TE Connectivity

Product Change Notification: P-20-019934

General Product Description:

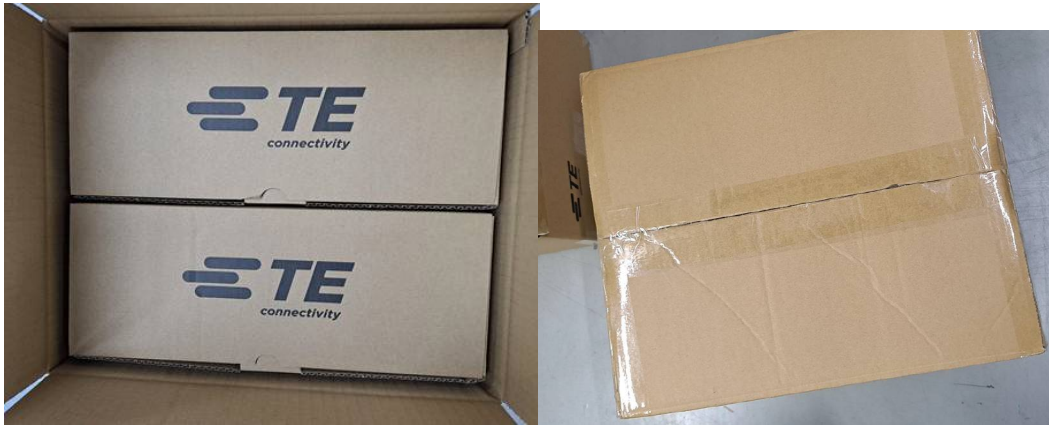
---Test result: There was no products damaged and defect after drop test.

---The corner of shipping box impacted were extremely distorted, but not damaged
